## **FAA Questions and Comments Through ARAC Ex-Com on the June 2001 FTIHWG Final Report**

Figure 1

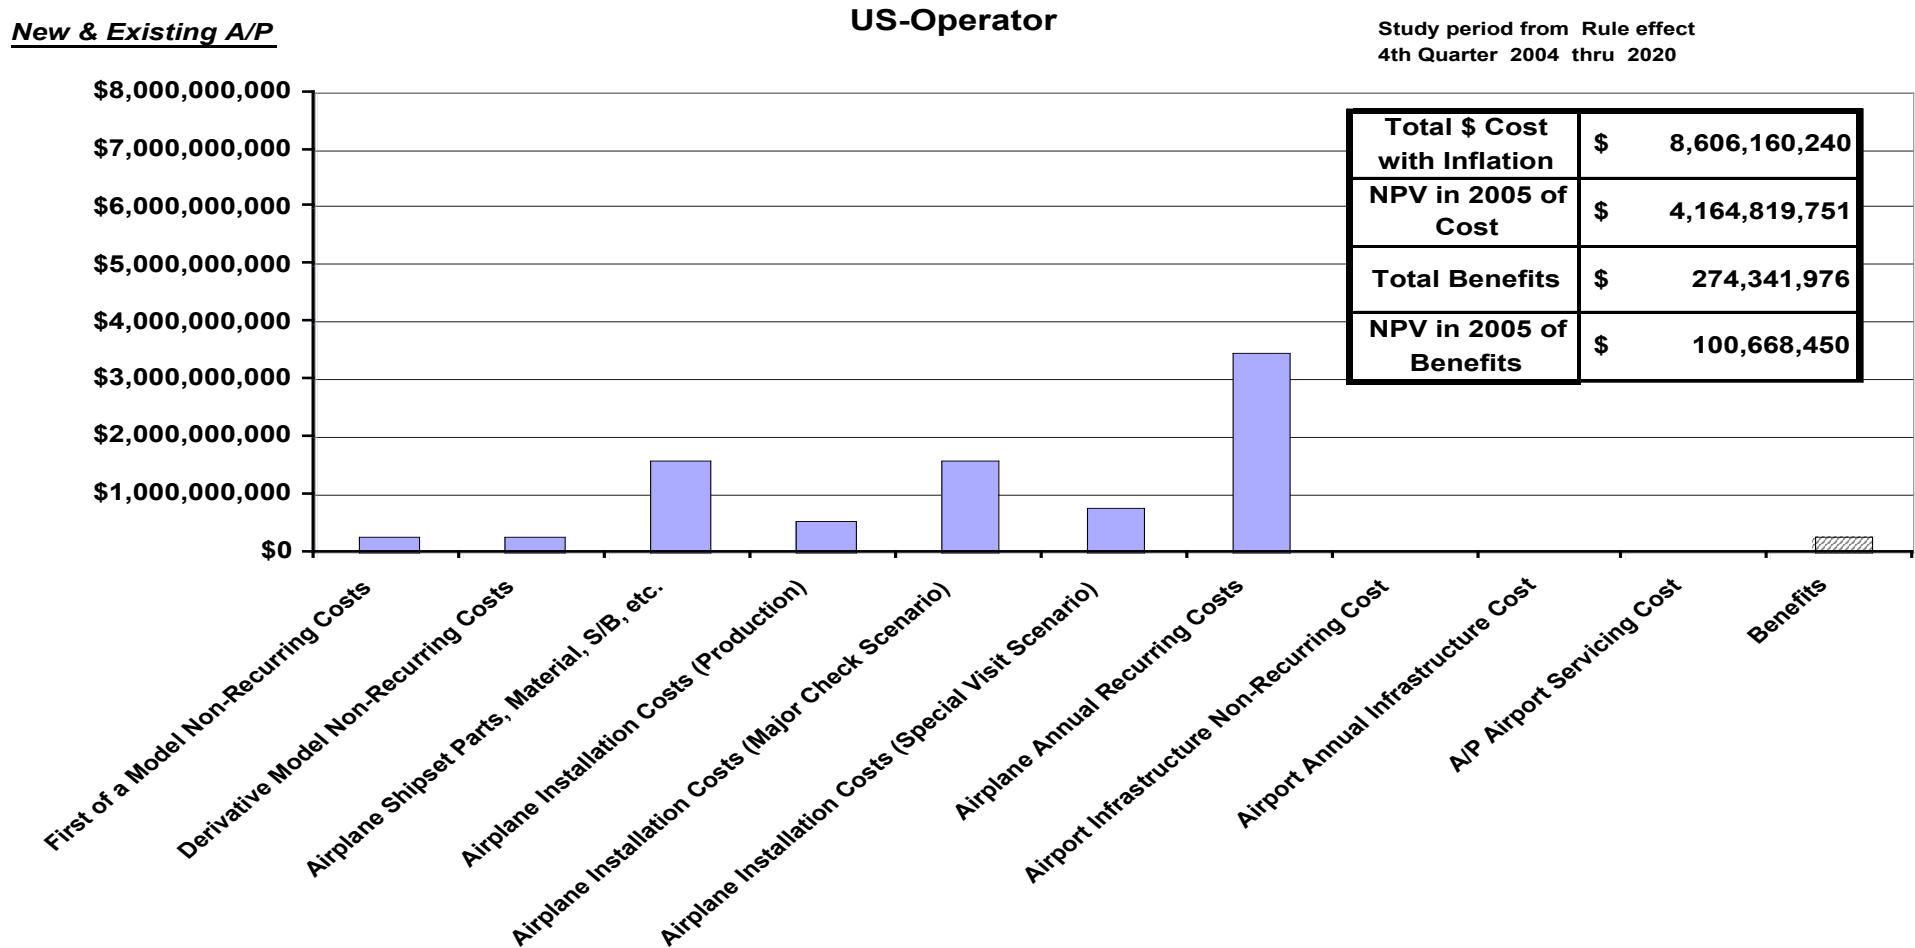
The report does not identify separate costs to implement fuel tank inerting concepts on in-service, new production and new airplane designs. Include costs for each category of airplane in the Executive Summary for both the basic report and the Sensitivity Analysis.

The cost summary charts in the report combine the costs and benefits for in-service, production and new airplane designs. As an example, two scenarios are included below to show the results for separate categories airplanes. Figures 1-3 show the costs and benefits for scenario 7.

Figure 1 is the combined cost of new and existing airplanes. Figure 2 is the combined retrofit cost of the fleet only. Figure 3 is the combined cost of new airplanes only. Figure 4 is the combined cost of new and existing airplanes. Figure 5 is the combined cost for retrofit of the existing fleet only. Figure 6 is the combined cost of new airplanes only.
